1818 6TH AVE

601 Stewart St, 1818 6th Ave, 600 Olive Way
Project #: 3038765-LU

DRB RECOMMENDATION MEETING

DOWNTOWN DESIGN REVIEW BOARD
December 13, 2022

GASKET ARTICULATION – **PREFERRED OPTION**

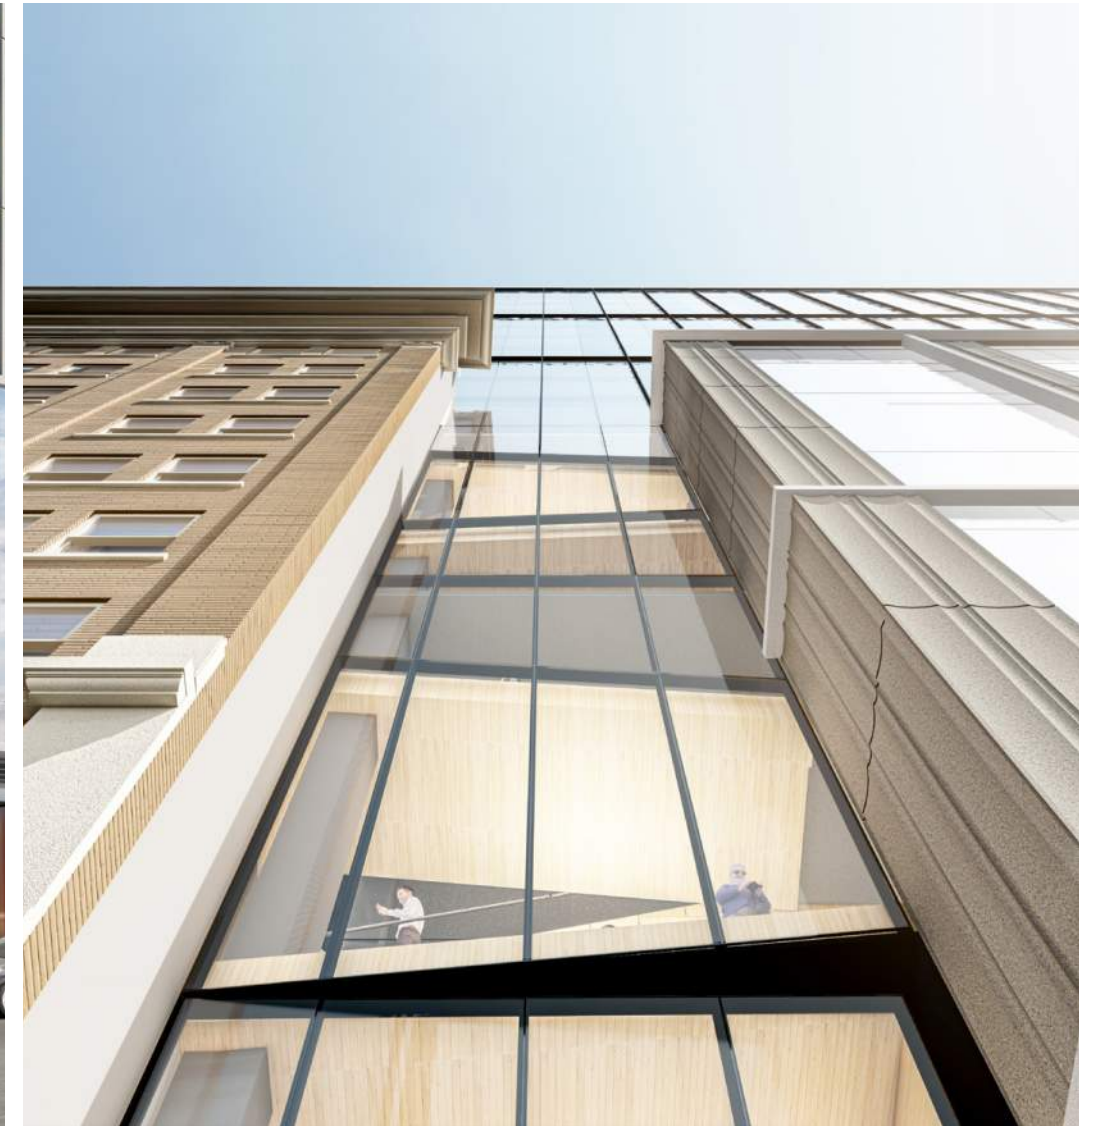
BOARD COMMENT	DESIGN RESPONSE
<p>EDG #1 (1/4/2022) Massing Concept 1b</p> <ul style="list-style-type: none"> • The Board supported the concept of the “spatial stitch” • The Board requested further study of how the gasket and entry reinforces the architectural concept and makes the interior space feel as though it is part of the public realm • <i>B-4: Design a well-proportioned & unified building, B-4.2: Coherent Interior/Exterior Design, B-4.3: Architectural Details, and C-4: Reinforce building entries</i> 	<ul style="list-style-type: none"> • Various glazing types being studied to achieve high transparency • Mullion patterns simplified to focus on the sloping floor plates (connecting new tower to Lloyd) • Upper cornice bands preserved to provide relief and depth to the existing southern wall

The Landmarks Preservation Board supports the preferred option per meeting on 10/28/2022

Landscape Roof Plan – Lloyd Roof (L9)

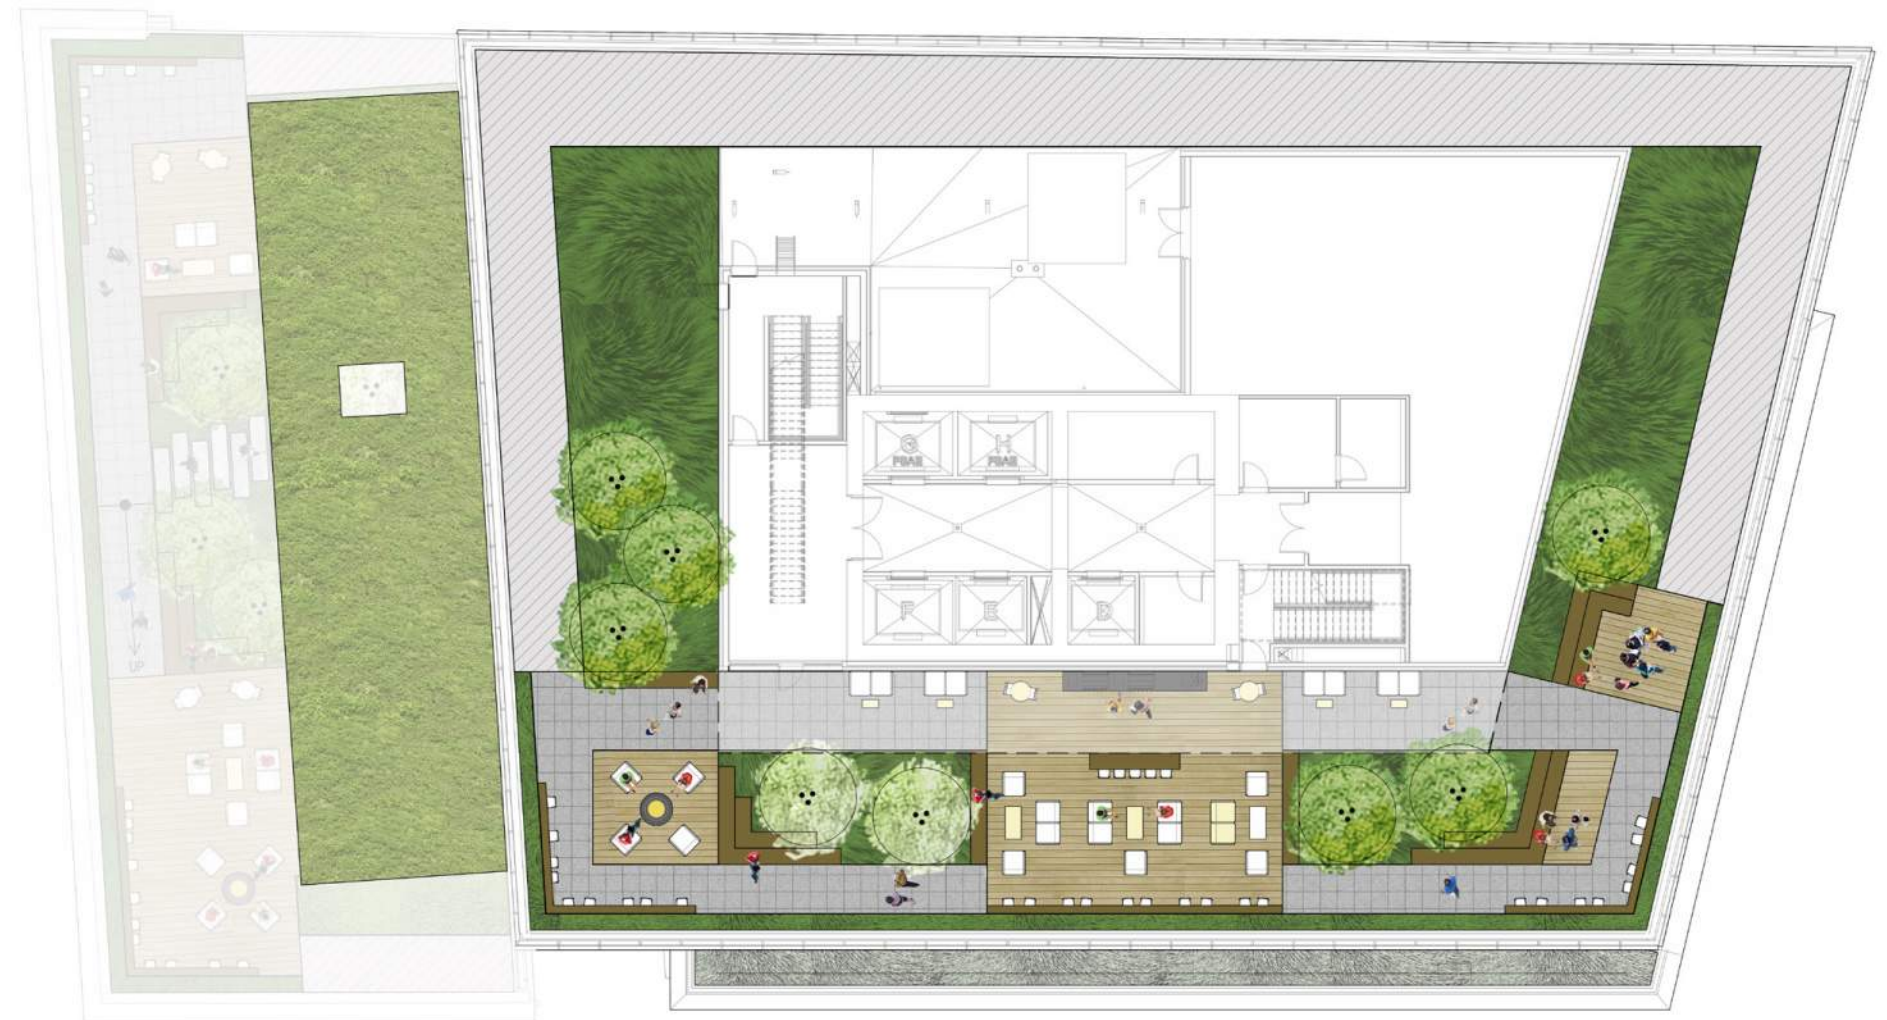
BOARD COMMENT	DESIGN RESPONSE
<p>EDG #1 (1/4/2022) Massing Concept 1c</p> <ul style="list-style-type: none"> The Board supported the proposal to step back the new portion of the mass above the historic Lloyd Building The Board requested a thoughtful rooftop landscape plan; further study of how the “spatial stitch” is expressed on the rooftop; and more information on how the rooftop penthouses and other services will be integrated into the overall massing form. <i>A-1: Respond to Context, A-2.2: Rooftop Mechanical Equipment, and B-4: Design a well-proportioned and unified building</i> 	<ul style="list-style-type: none"> Rooftop plans have been developed to consider views, amenities, equipment and maintenance Lloyd rooftop canopy collects necessary stair and elevator overruns into singular element while providing year-round weather protection The Lloyd rooftop canopy extents have been carefully considered to limit its visibility from street level

EAST ALLEY ELEVATION

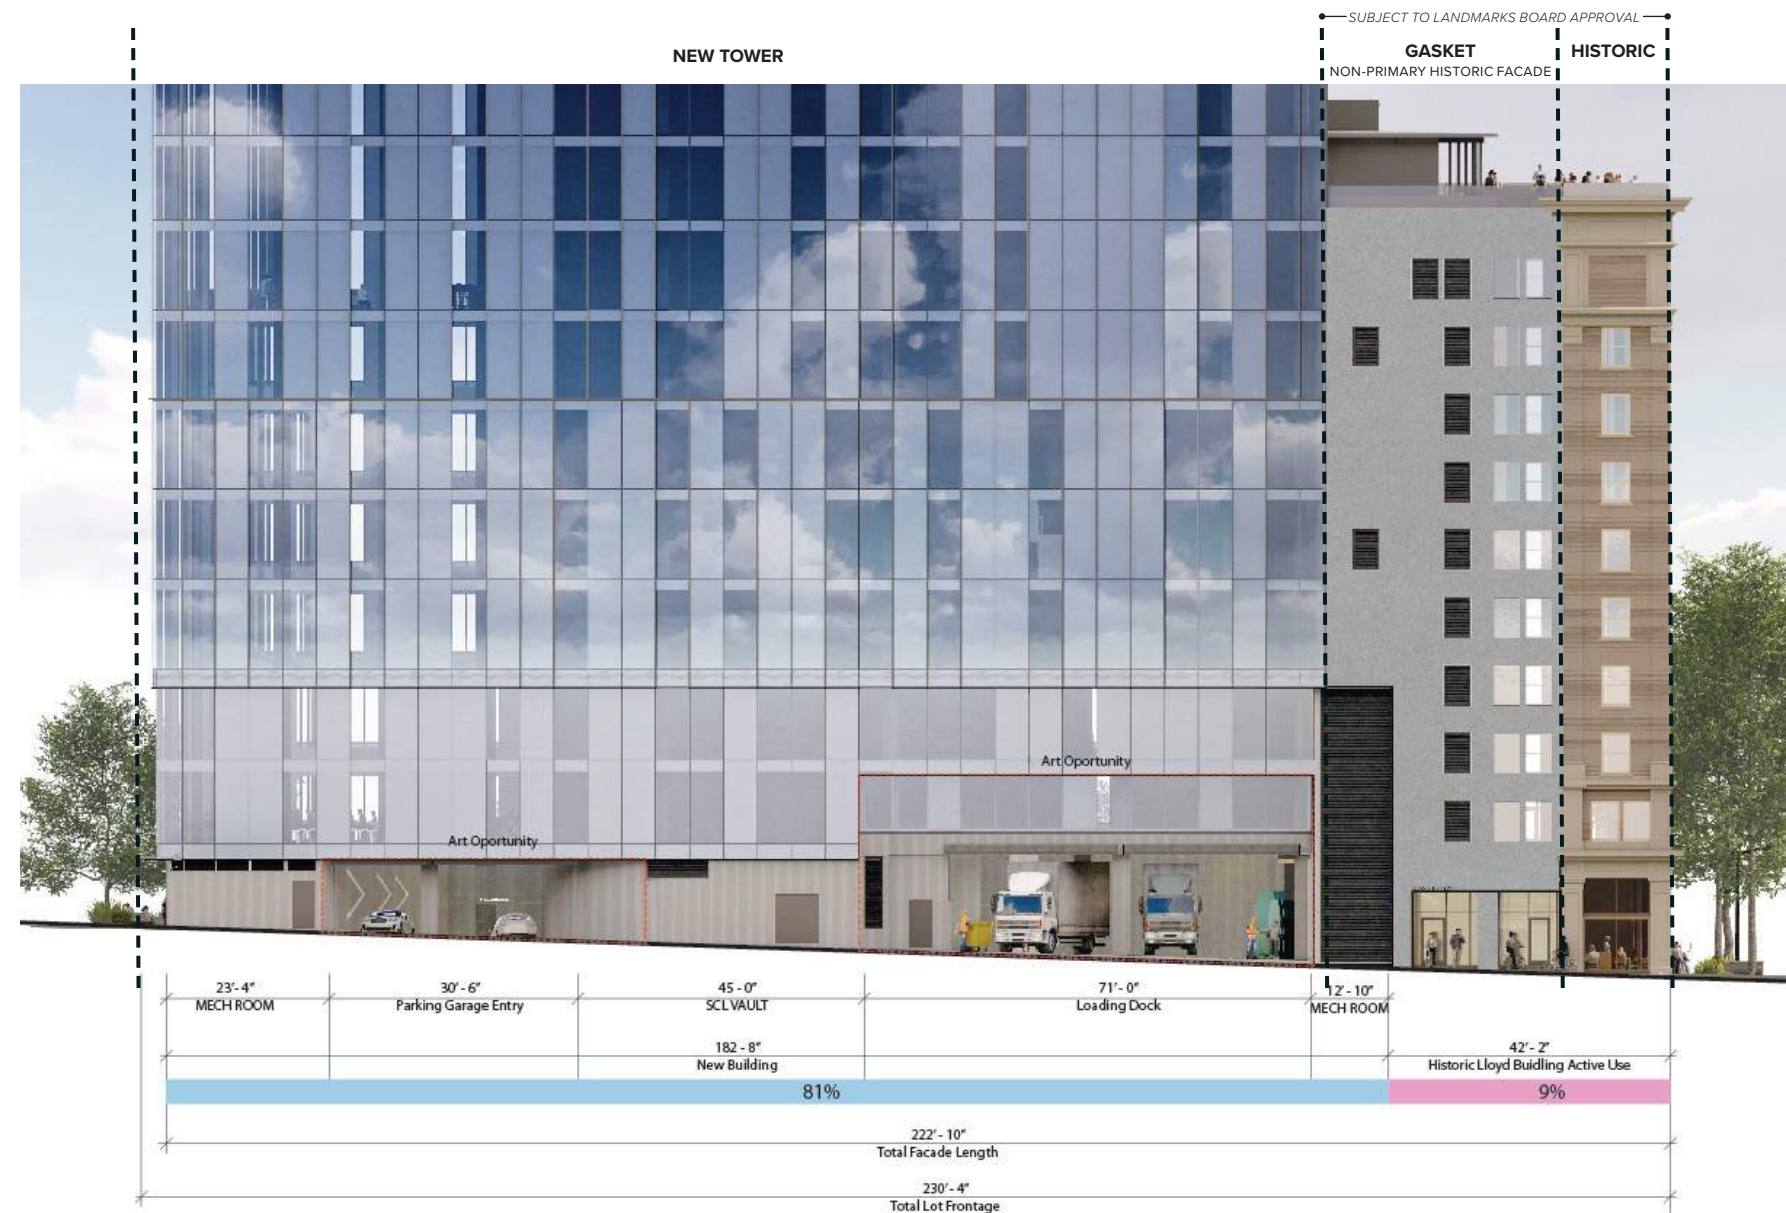
BOARD COMMENT	DESIGN RESPONSE
<p>EDG #1 (1/4/2022) Massing Concept 1d</p> <ul style="list-style-type: none"> The Board directed further study of how the gasket is carried around the mass and the "spatial stitch" is articulated on the alley façade The Board requested an alley elevation and more information in the Recommendation packet on how "the new meets the old". A-1: Respond to the physical environment, C-6: Develop the Alley Façade, and B-4.3: Architectural Details 	<ul style="list-style-type: none"> The existing non-primary Lloyd facade acts as the gasket between new and historic The simplicity of the gasket provides relief from the highly articulated historic façade and the rhythmic patterning of the new tower Ground floor alley façade has been activated with a generous bike entry and alcove at north end

FACADE PATTERNING

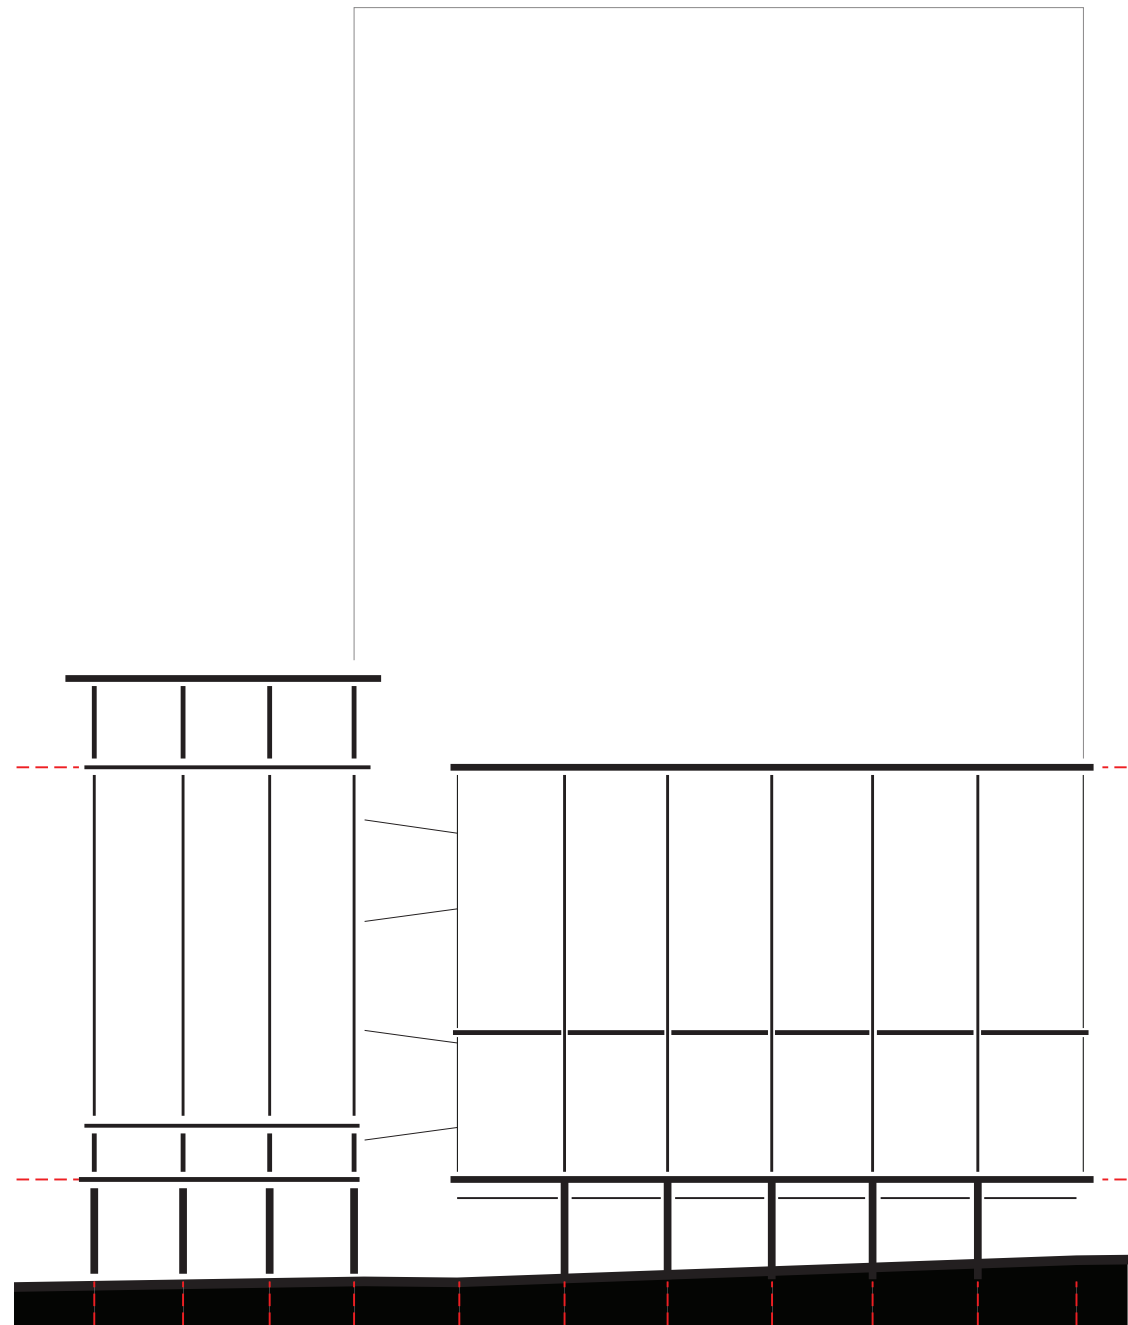
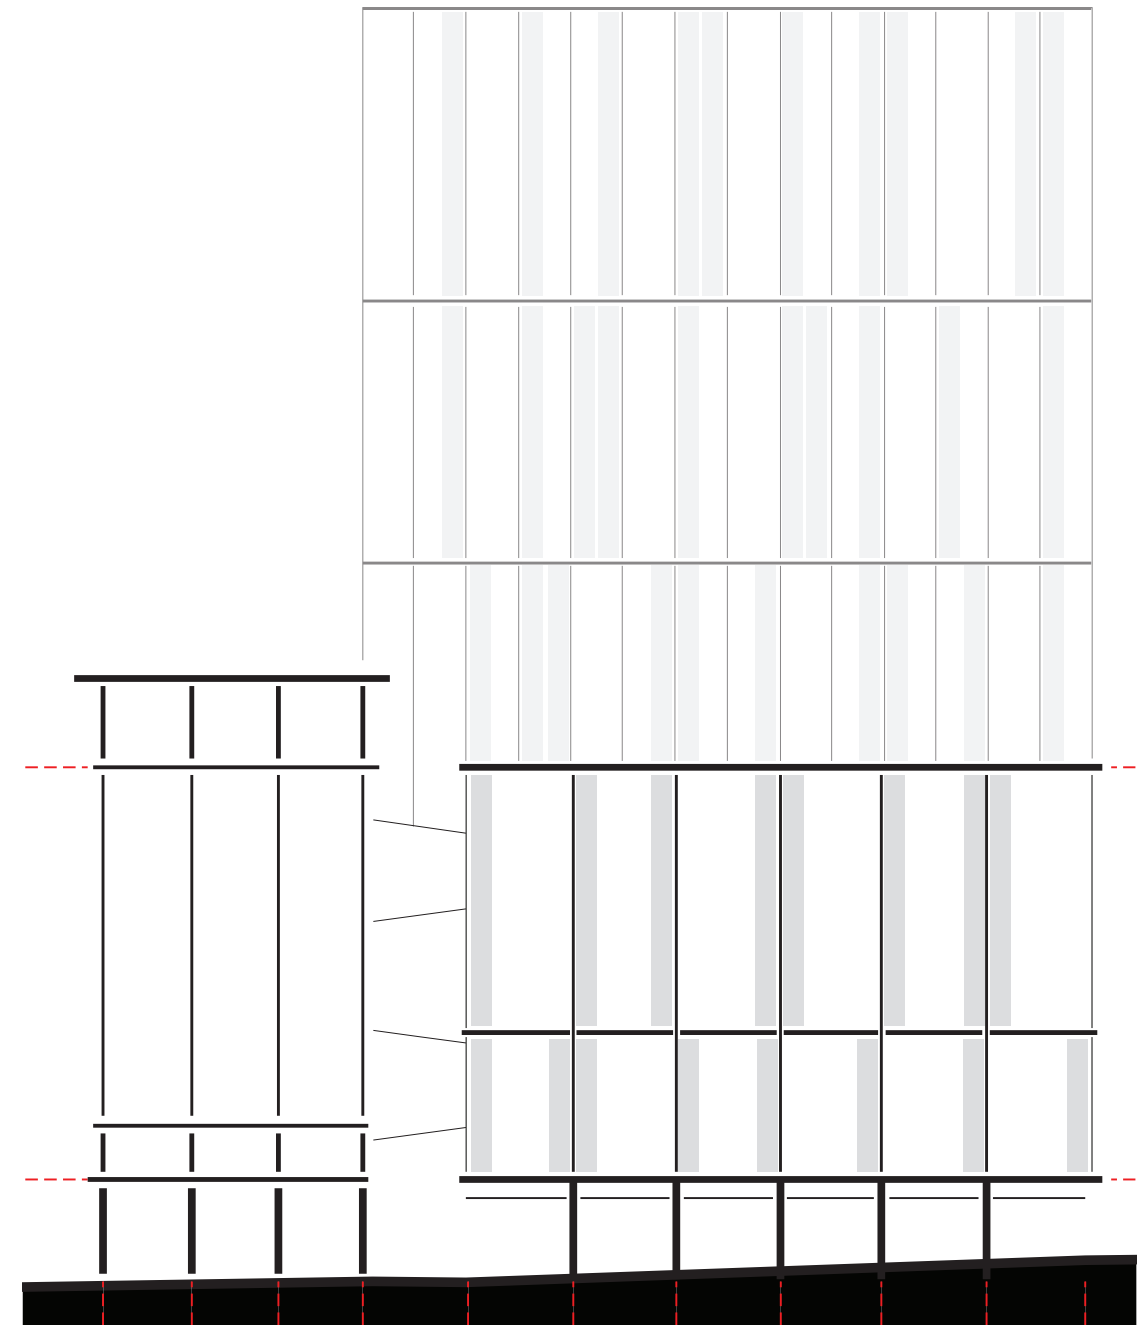
BOARD COMMENT	DESIGN RESPONSE
<p>EDG #1 (1/4/2022) Massing Concept 1e</p>	<ul style="list-style-type: none"> As it relates to the mass and façade development, the Board specifically prioritized the following Downtown Design Guidelines: A-1: Respond to the Physical Environment A-2: Enhance the Skyline B-1.1: Adjacent Features and Networks B-2.1: Analyzing Height, Bulk, and Scale B-3: Reinforce the Positive Urban Form and Architectural Attributes of the Immediate Area B-4: Design a Well-Proportioned and Unified Building
<ul style="list-style-type: none"> The design team is in agreement with the Board's cited Design Guidelines and will continue prioritizing those directives.

- Key datums from Lloyd Building inform subdivision of new podium
- Similar proportion and scale of retail bays
- Special attention to hierarchy between horizontals and verticals

- Vertical fins subdivide the tower facade into 10' bays
- Horizontal fins introduce three tiers to the tower facade and establish bay proportions similar to Lloyd building
- Shifting opaque shadowbox panels introduce a subtle playful patterning to the facade
